SUBJECT: Entergy Nuclear Operations, Inc.  
Pilgrim Nuclear Power Station  
Docket No. 50-293  
License No. DPR-35

License Renewal Application, Amendment 2

LETTER NUMBER: 2.06.049

**Pilgrim Nuclear Power Station Drywell Shell Information**

PILGRIM NUCLEAR POWER STATION DRYWELL INFORMATION

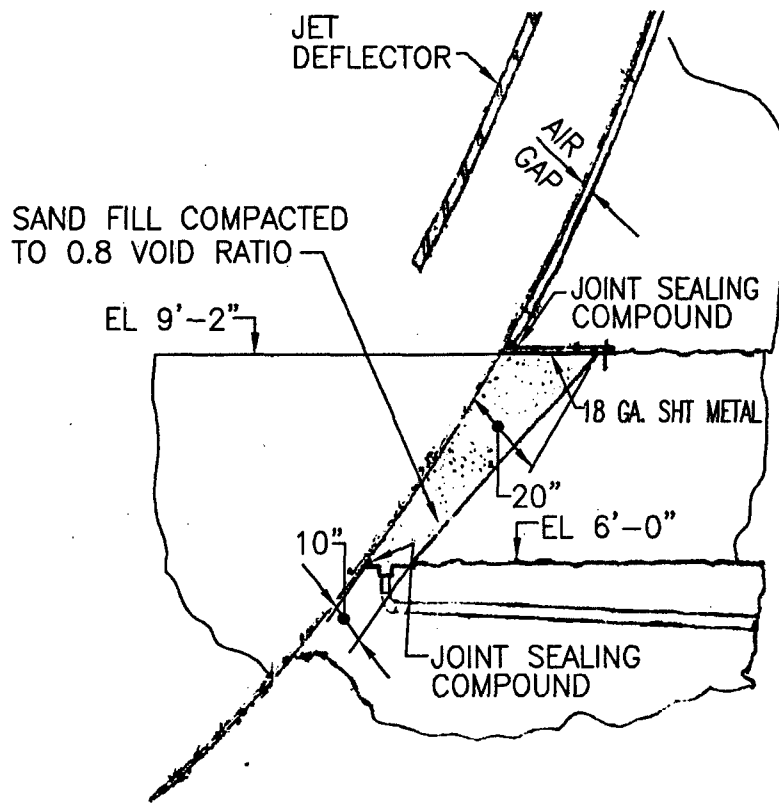
Based on recent discussions between industry and the NRC staff, Entergy provided additional information concerning the drywell shell in the referenced letter. The attachment of this letter provides more detail regarding specific elevations (i.e. addition of inches) in the "Operating Experience and Actions Taken to Prevent Drywell Corrosion" section of the attached information on the drywell shell. For convenience, change bars are included to assist in identifying these specific elevations. Moreover, this letter replaces the figure of the sand pocket (page 6 of 6 of the attachment contained in the referenced letter) with a nearly identical figure that is more legible.
